DRB Comments

ITEM # 14

PROJECT # 1008689

RE: Tracts E-1 & E-2, Netherwood Park

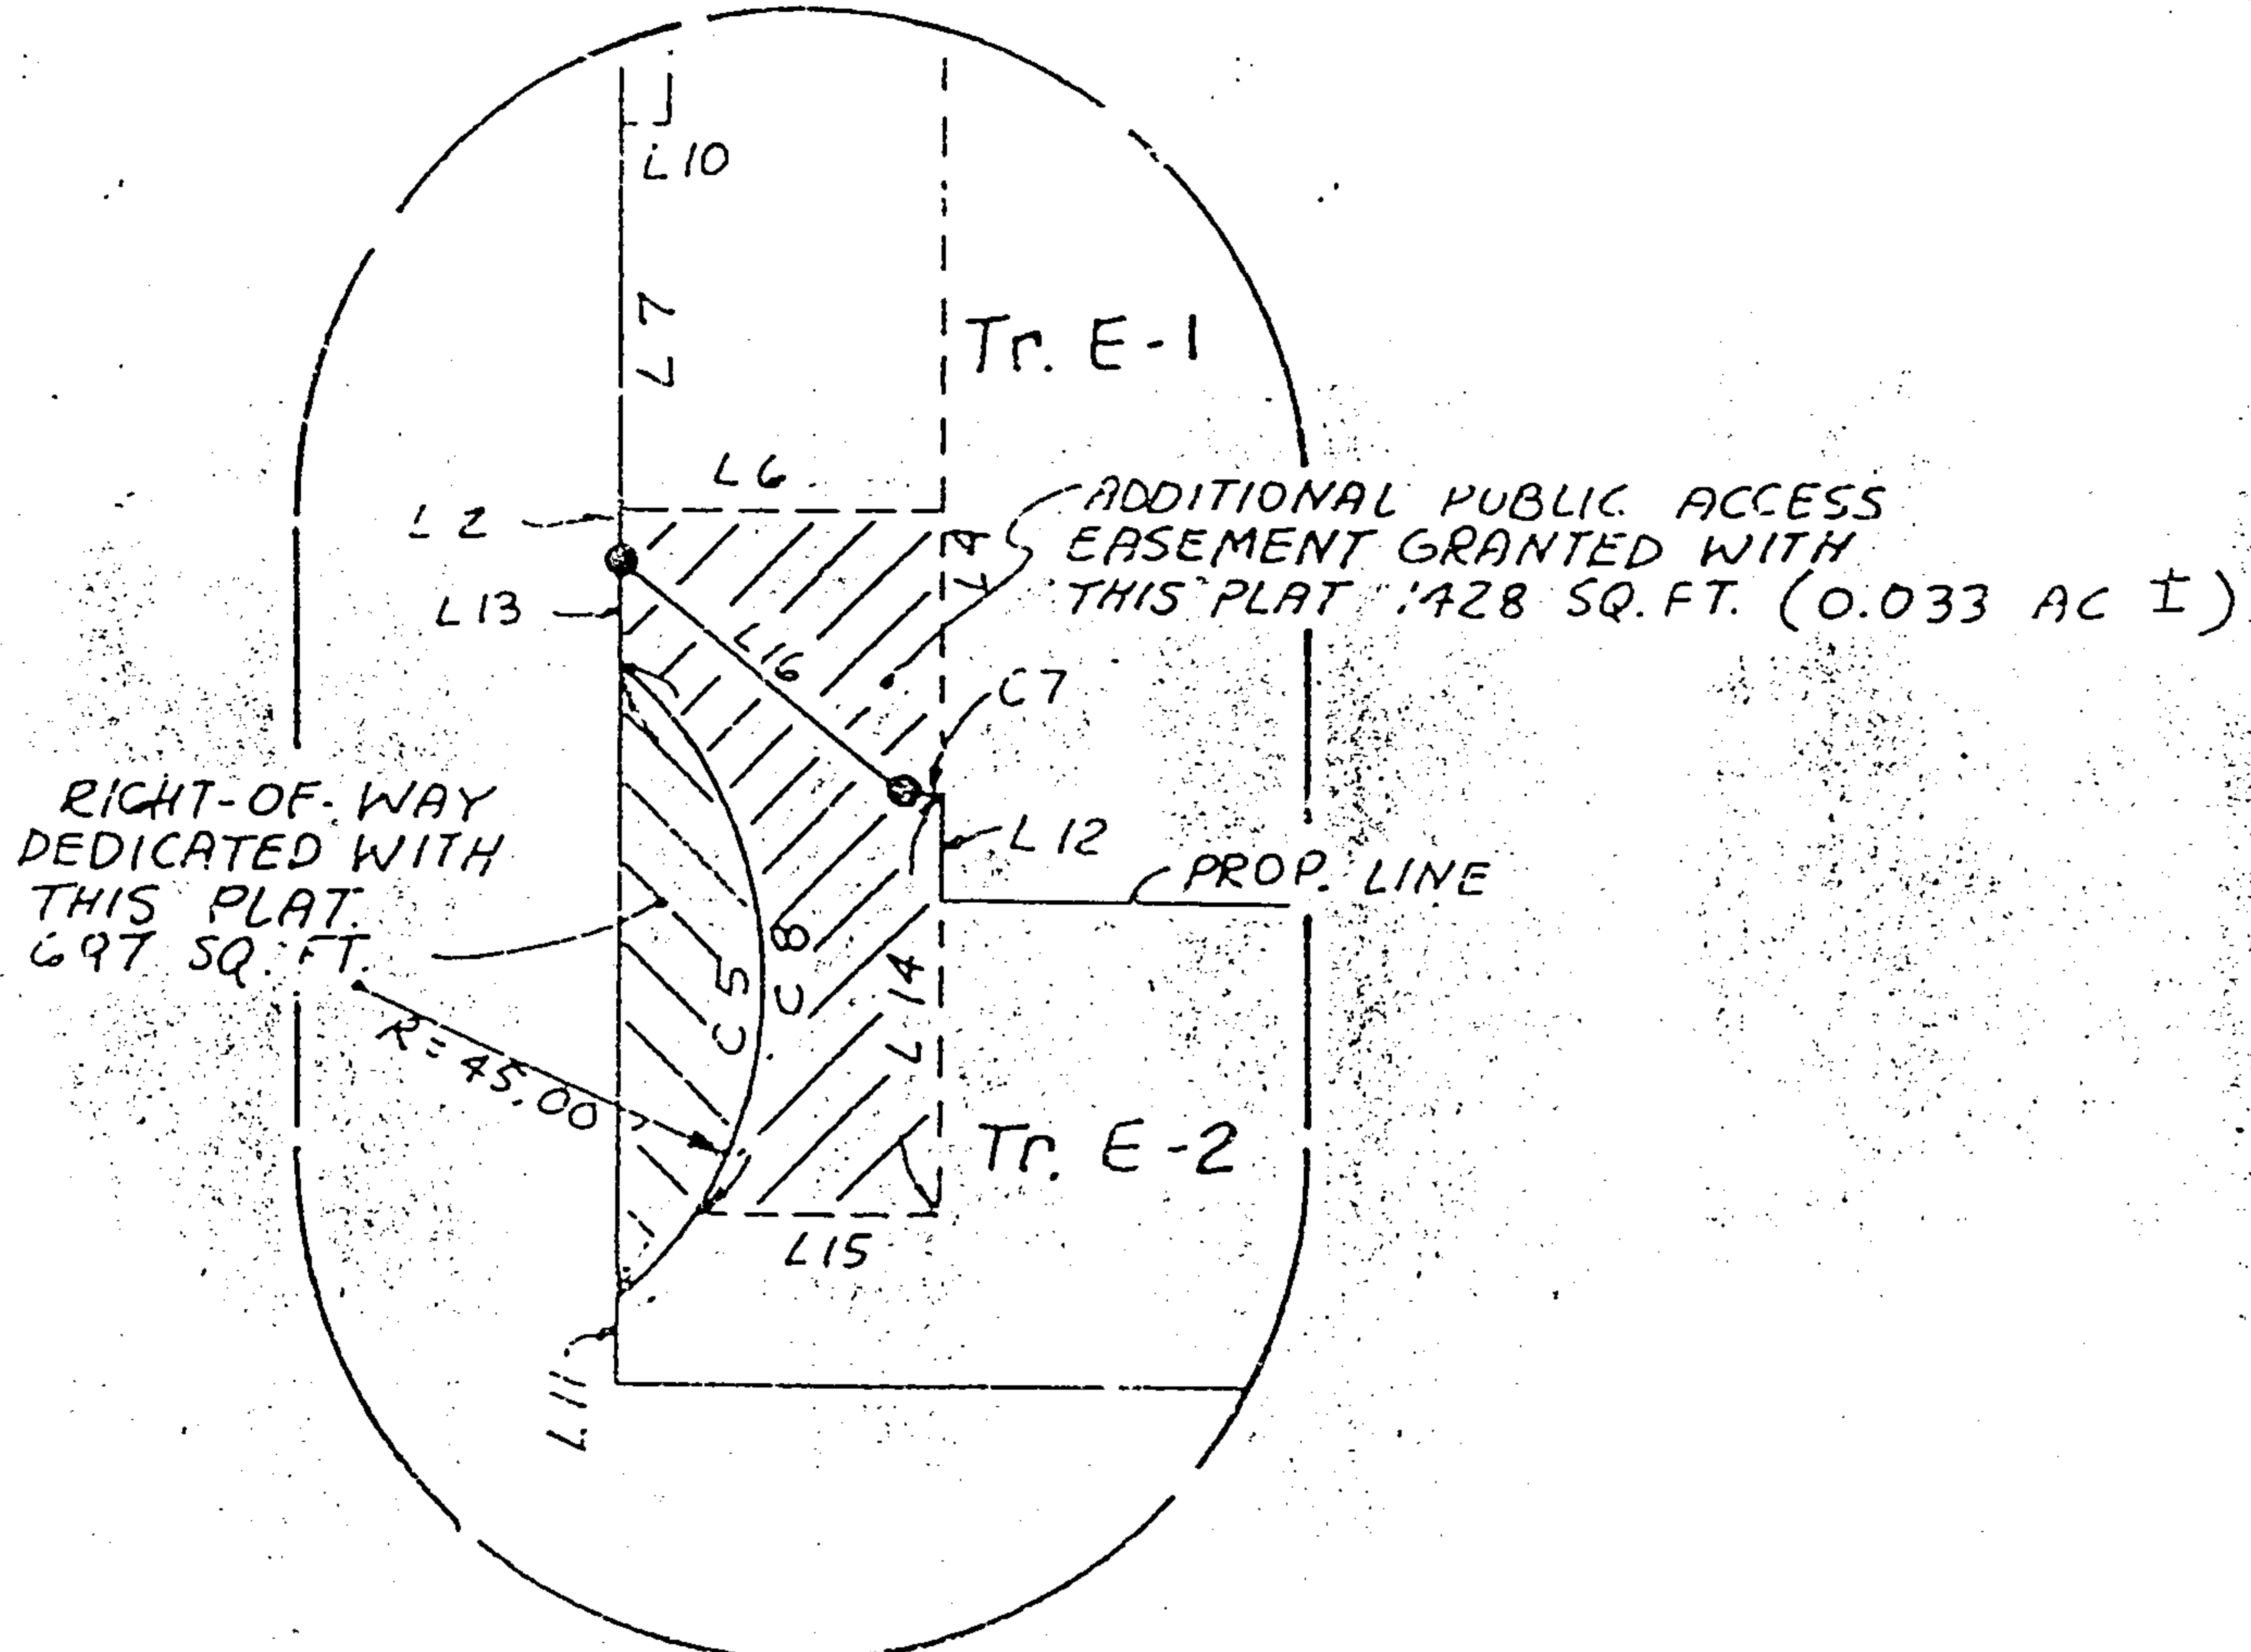
The proposed lots would have to conform to City codes and ordinances. A licensed architect or engineer would have to certify that the building meets the fire code for zero-lot line (lot line through the building). Additionally, Zoning Enforcement would have to verify that each lot meets the on-site parking requirement for the building(s) on each lot.

Additionally, please be advised of the notations on the recorded plat. Development to include platting of Tract E-2 could result in a requirement for major public infrastructure.
